STAIR POST
 BASE PLATE DETAIL 1
 SCALE: 1"=1'-0" S501 S201

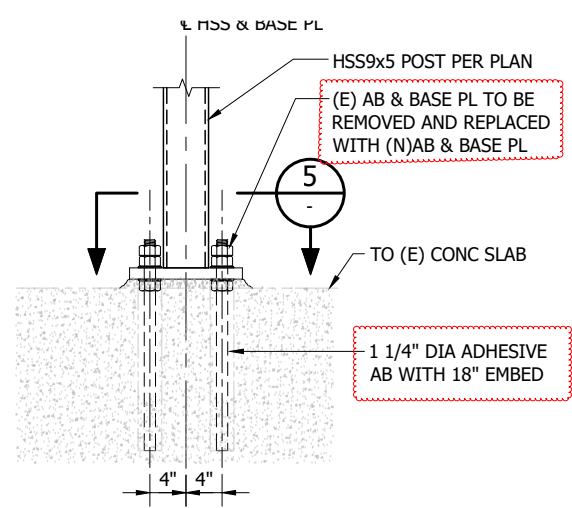
Proposed. (Reusing the exact anchor hole pattern and location and only increasing the Embedment depth.)
